Attached is a Field Safety Notice/Field Corrective Order pertaining to the Allura Xper FD20 Biplane due to FCO 72200354. Please note that the serial number of the units affected are stated below:

URGENT - Field Safety Notice

Allura Xper systems

7th or 8th monitor on the Monitor Ceiling Suspension may disengage

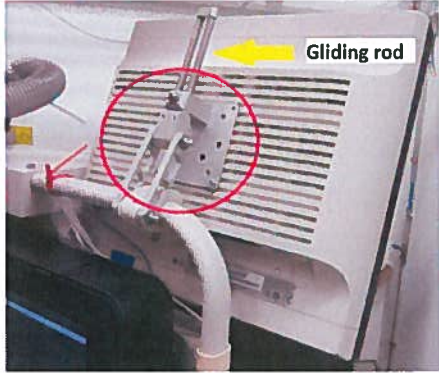
<p>PROBLEM DESCRIPTION</p>	<p>Extra monitors, so called 7th or 8th monitor, mounted on the Monitor Ceiling Suspension (MCS), might disengage from the MCS and fall down. The two small set screws securing the two gliding rods into an aluminum block of the support arm can come loose because of vibrations and forces exerted on them.</p> <p>If the set screws have come loose gravity can keep the rods in position. However, if a force is exerted on the monitor pushing it forward, the monitor can topple forward. Once the monitor has toppled over it is only attached with its wires. If the monitor breaks loose of its wires it will drop on the floor.</p> <div style="display: flex; justify-content: space-around;">   </div>
<p>HAZARD INVOLVED</p>	<p>If the above described problem occurs, it may lead to harm to patient, user, bystander or service engineer, that may necessitate medical intervention.</p>
<p>HOW TO IDENTIFY AFFECTED PRODUCTS</p>	<p>All units of the systems identified in the section "Affected Products" above with an attached 7th or 8th monitor are affected. Your local Philips organization will help you confirm that all of your affected systems have been identified.</p>

<p>ACTION TO BE TAKEN BY CUSTOMER / USER</p>	<ul style="list-style-type: none"> • Verify if the facility has a 7th or 8th monitor attached to the Monitor Ceiling Suspensions (MCS) <div style="text-align: center;">  </div> <ul style="list-style-type: none"> • Position an MCS with a 7th or 8th monitor only before or after an examination. • Avoid positioning the MCS above a patient/sterile field during the examination. • Users must ensure that all staff with access to the affected system are informed of the contents of this Field Safety Notice. • The customer is requested to place this field safety notice with the documentation of the system until this correction has been implemented.
<p>ACTIONS PLANNED BY PHILIPS</p>	<ul style="list-style-type: none"> • All possibly affected products in the field will be corrected free of charge. • A Philips representative will secure the set screws in the affected systems. This will effectively make it impossible for the set screws to loosen under the prevailing conditions. • You will be contacted by our local Philips representative to schedule an appointment to make the necessary corrective action. • This action will start effective December 2017.
